Mather Air Force Base

Five-Year Review of Remedial Actions

SUBJECT: Transmittal of Signed Five-Year Review Report for Mather AFB

Response to Comments on Draft Mather Five-Year Review

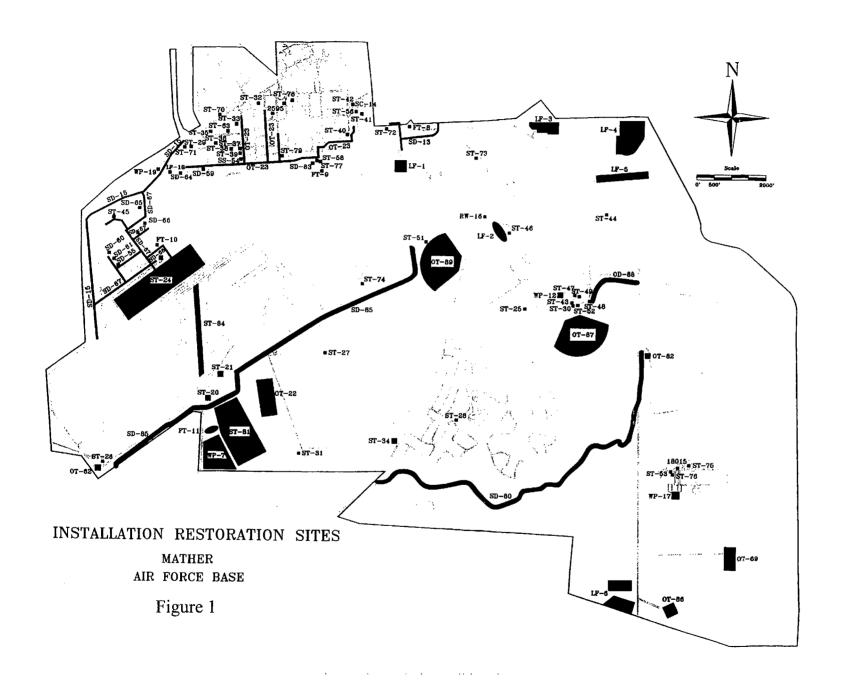
DTSC comment #7: Page 2-17, Section 2.5. 1. A Figure 1.1 is mention. This is probably a typographical error.

Response: The reference has been corrected; it now refers to Figure 1.

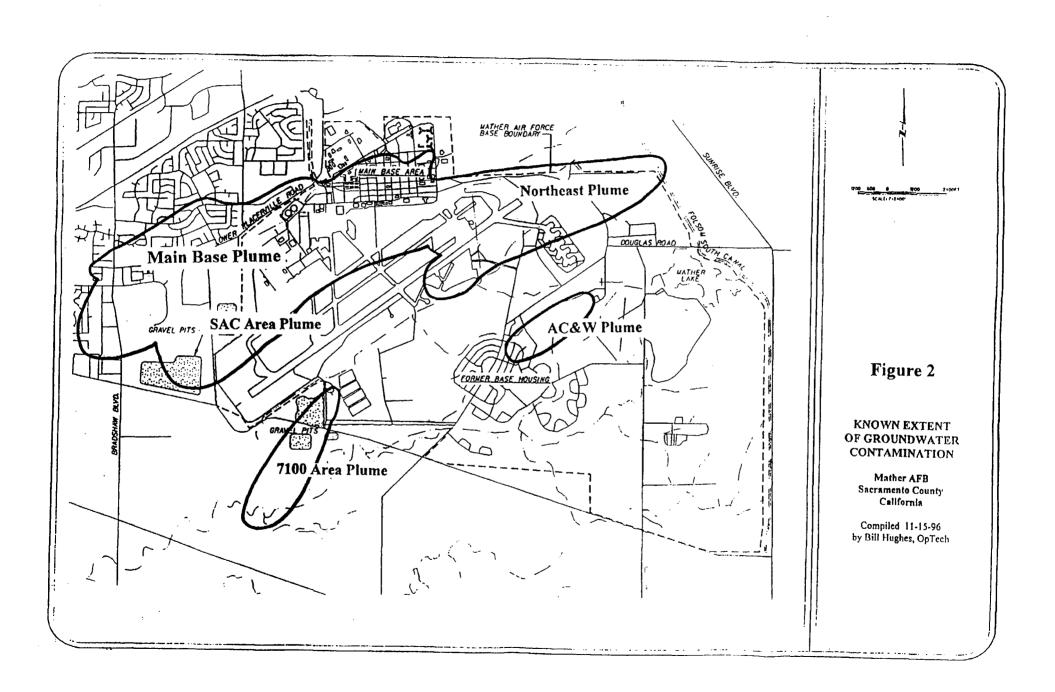
DTSC comment #1: The document did not contain Figure 2.

Response: Figure 2 has been included in the revised report.
